Product Change Notice for EVQV5 & EVQV6 Series

PCN.PG26.10.21.2015

10/21/15

Marking Definition:

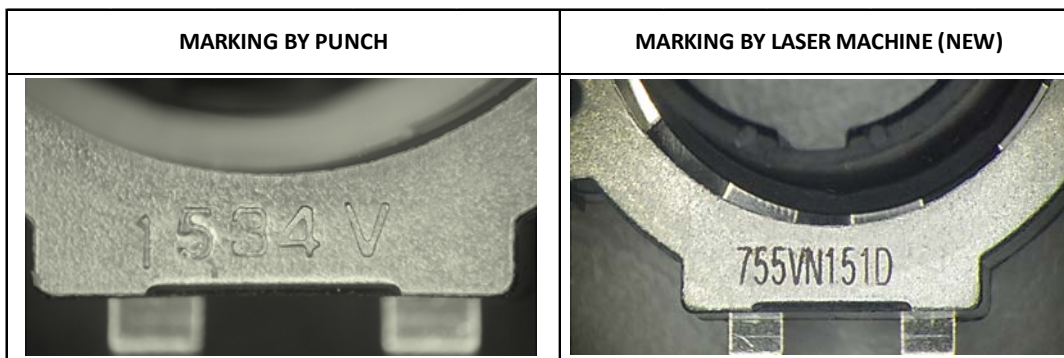
About this Notice:	As part of Panasonic's continuous strive for improvement, Panasonic shall change the marking method from punching to laser etching on all EVQV5 and EVQV6 series. This change will improve production efficiency and speed.
Effective Date:	December 1, 2015
Change Details:	See below for example of new marking and marking definition. Marking change has no effect to the product specs.
Affected Parts:	All EVQV5 and EVQV6 part numbers, see attached file.
Datasheet(s):	See Attached
Notes:	None
